PCI-SIG ENGINEERING CHANGE NOTICE

TITLE:	Optimized Buffer Flush/Fill
DATE:	Updated 30 April 2009, original request: 8 February 2008
AFFECTED DOCUMENTS:	PCI Express Base Specification, Revision 2.0 PCI Express Base Specification, Revision 2.1 PCI Express CEM Specification, Revision 2.0 PCI Express Mini CEM Specification, Revision 1.2
SPONSORS:	Intel Corporation

Figure 2.x: OBFF Message

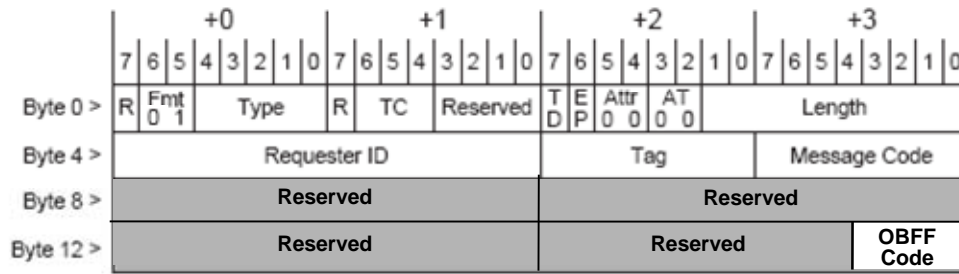
PCI Express Base Specification - add Section 2.2.8.x:

- <ref table below> defines the OBFF Message.
- The OBFF Message does not include a data payload (TLP Type is Msg).
- 20 The Length field is reserved.
- The Requester ID must be set to the Transmitting Port's ID
- The OBFF Message must use the default Traffic Class designator (TC0). Receivers that implement OBFF support must check for violations of this rule. If a Receiver determines that a TLP violates this rule, it must handle the TLP as a Malformed TLP.
- 25
 - This is a reported error associated with the Receiving Port (see Section 6.2)

Figure 6-x: OBFF Codes and Equivalent WAKE# Patterns

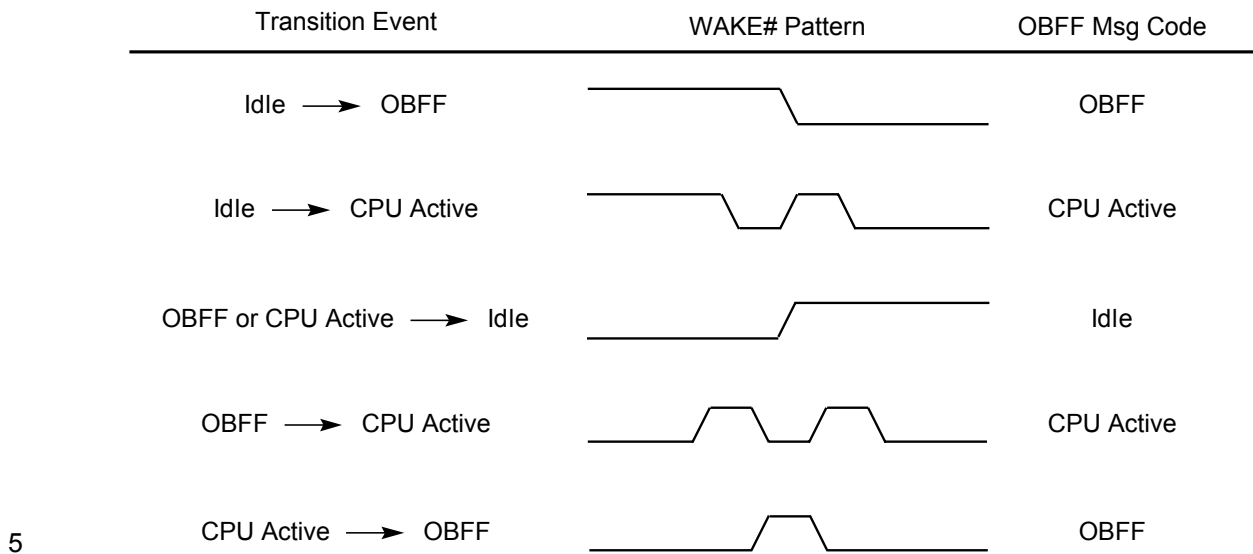
These codes correspond to various assertion patterns of WAKE# when using WAKE# signaling, as shown in <ref figure 6-x below>. There is one negative-going transition when signaling OBFF and two negative going transitions each time CPU Active is signaled. The electrical parameters required when using WAKE# are defined in the WAKE# Signaling section of PCI Express CEM Specification, Revision 2.0 (or later).

Figure 06-y: Example Platform Topology Showing a Link Where OBFF is carried by Messages

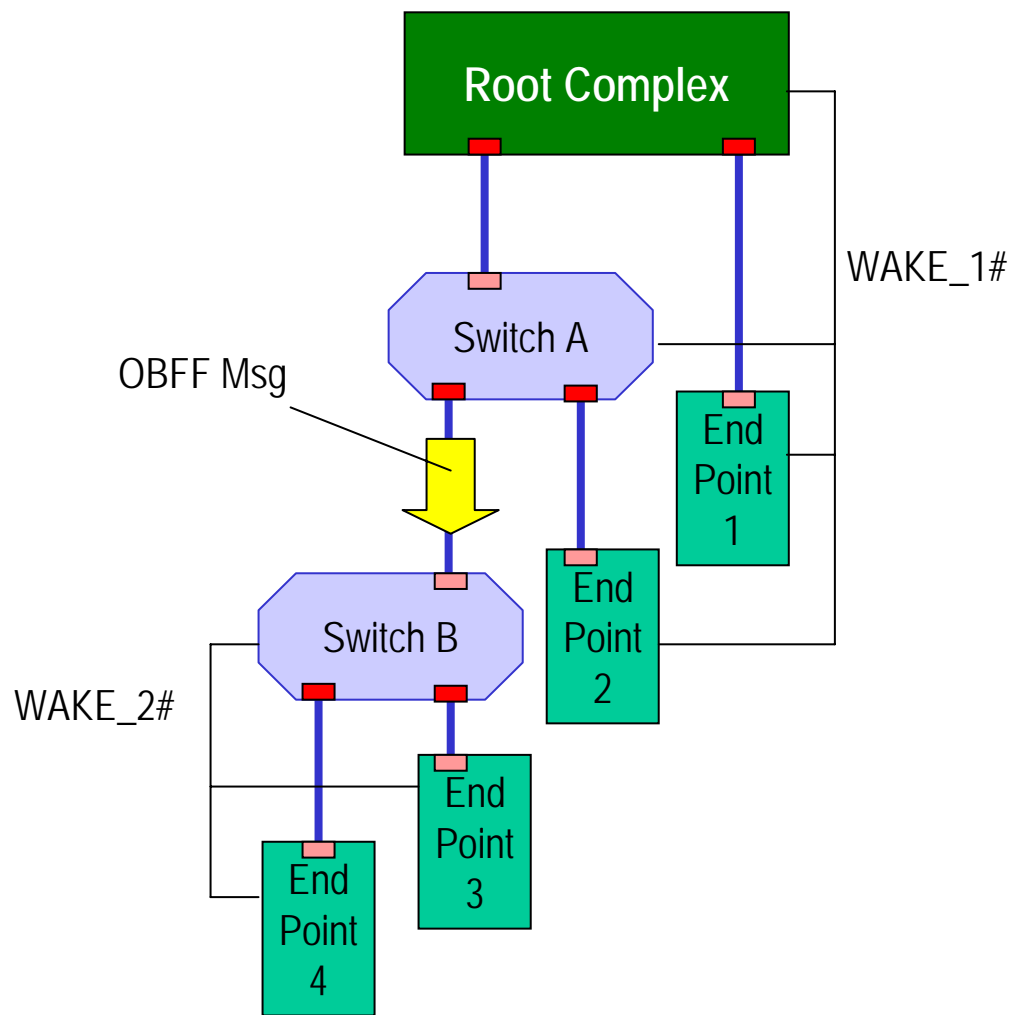
Figure <6-y> shows an example system where it is necessary for a Switch (A) to translate OBFF indications received using WAKE# into OBFF Messages, which in this case are received by another Switch (B) and translated back to using WAKE# signaling. A HwInit configuration mechanism (set by hardware or firmware) is used to identify cases such as shown in this example (where the link between Switch A and Switch B requires the use of OBFF Messages), and system firmware/software must configure OBFF accordingly.

7.8.16. Device Control 2 Register (Offset 28h)

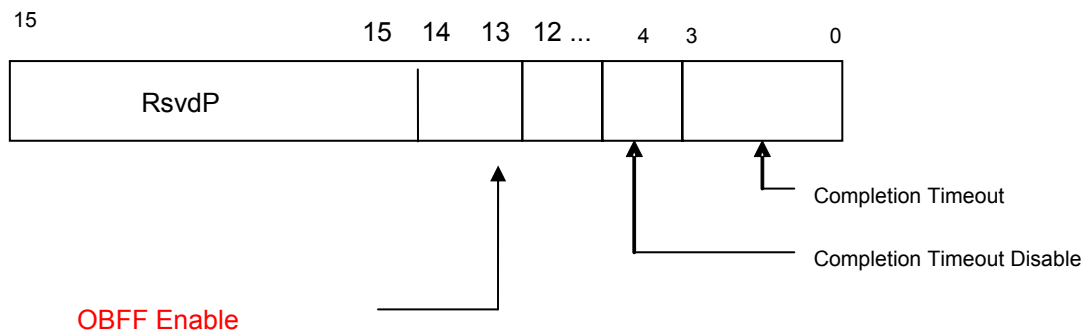
PCI Express Base Specification - change Figure 7-25 and Table 7-24 in Section 7.8.16 as follows:

Bit Location	Register Description	Attributes
...		
<u>14:13</u>	<p>OBFF Enable –</p> <p><u>00b – Disabled</u></p> <p><u>01b – Enabled using Message signaling [Variation A]</u></p> <p><u>10b – Enabled using Message signaling [Variation B]</u></p> <p><u>11b – Enabled using WAKE# signaling</u></p> <p><u>See Section <6.x!!!> for an explanation of the above encodings.</u></p> <p><u>This field is required for all Ports that support the OBFF Capability.</u></p> <p><u>For a Multi-Function Device associated with an Upstream Port of a Device that implements OBFF, the field in Function 0 is of type RW, and only Function 0 controls the Component's behavior. In all other Functions of that Device, this field is of type RsvdP.</u></p> <p><u>Ports that do not implement OBFF are permitted to hardwire this field to 00b.</u></p> <p><u>Default value of this field is 00b.</u></p>	<u>RW /RsvdP (see description)</u>

Figure 2-14: WAKE# Rise and Fall Time Measurement Points

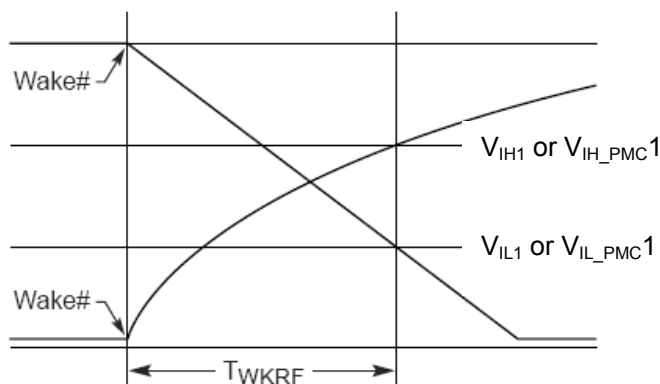
PCI Express CEM Specification - change Table 2-4 and Figure 2-14 in Section 2.6.2 as follows:

- Any supplied power is stable when it meets the requirements specified for that power supply.
- A supplied reference clock is stable when it meets the requirements specified for the reference clock. The PERST# signal is asserted and de-asserted asynchronously with respect to the supplied reference clock.
- The PERST# signal must be asserted within T_{FAIL} of any supplied power going out of specification.
- Measured from WAKE# assertion/de-assertion to valid input level at the system PM controller. Since WAKE# is an open-drain signal, the rise time is dependent on the total capacitance on the platform and the system board pull-up resistor. It is the responsibility of the system designer to meet the rise time specification.
- [Refers to timing requirement for indicating an active window.](#)
